# RECALL CAMPAIGN BULLETIN

NTB16-052a

## VOLUNTARY SAFETY RECALL CAMPAIGN OCCUPANT CLASSIFICATION SYSTEM REPROGRAMMING

This bulletin has been amended to correct Step 7 and Figure 1 on Page 4 and to correct Step 6 and Figure 25 on Page 9. Discard all previous copies of this bulletin.

### Front Passenger Air Bag Status Light

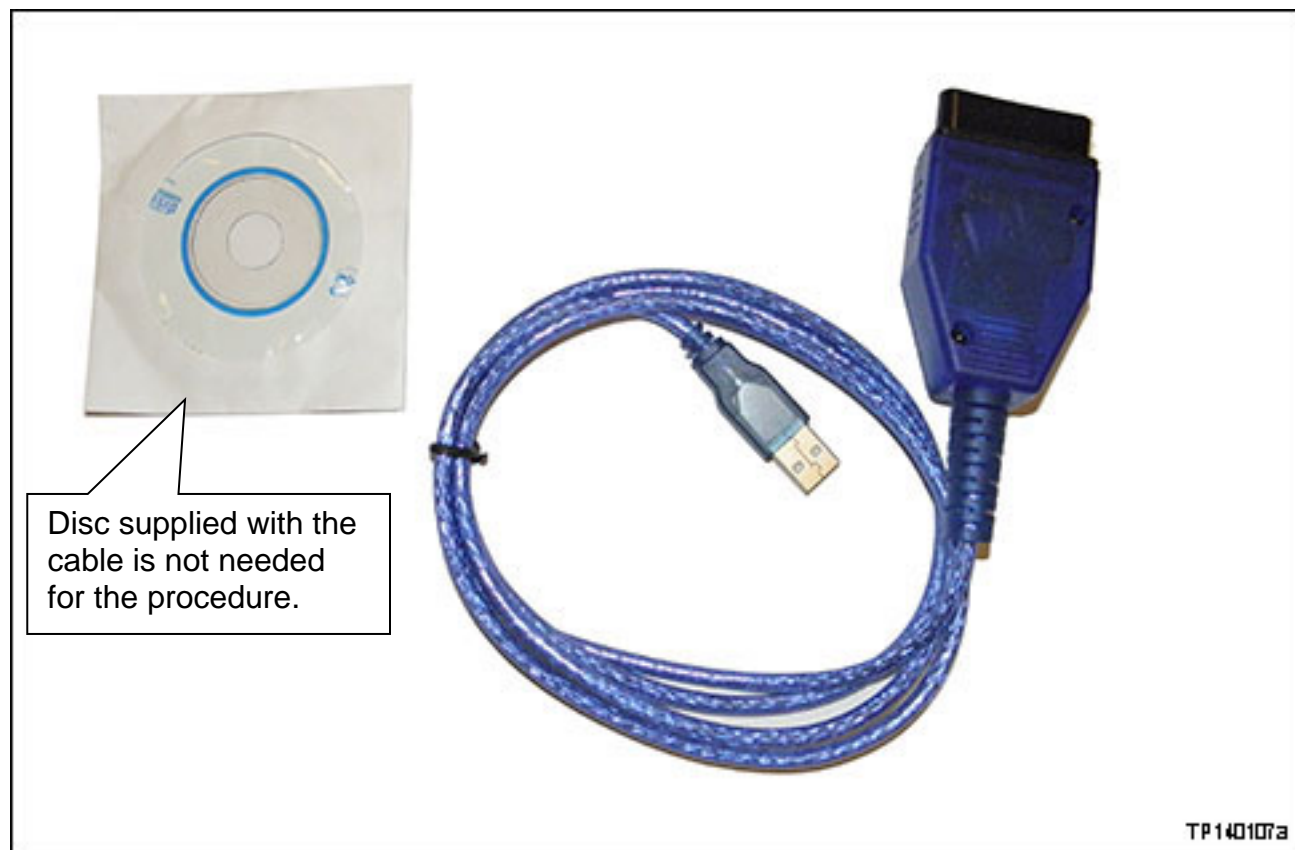
Performing the procedures in the bulletin (campaign R1609) changes the operation of the passenger air bag status light.

- After performing this campaign, the passenger air bag status light will be ON (illuminated) when the front passenger seat is empty.
